Commercial Vehicle Technology
Axle and Transmission Systems for Busses and Coaches

Quality information – AV133 axle, suspect screws used in flange shaft connection

AV133 Suspect screws at flange shaft connection

Needed spare parts:

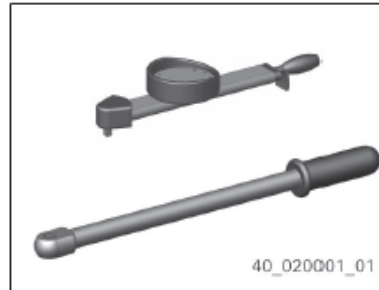
Screws with potential cracks used for the flange shaft connection on AV133 city bus axles

Change of the 20 potentially affected screws per axle

20 pcs. Torx screw 0750.108.991

Torque wrench 5870.203.016 (140 Nm to 800 Nm)
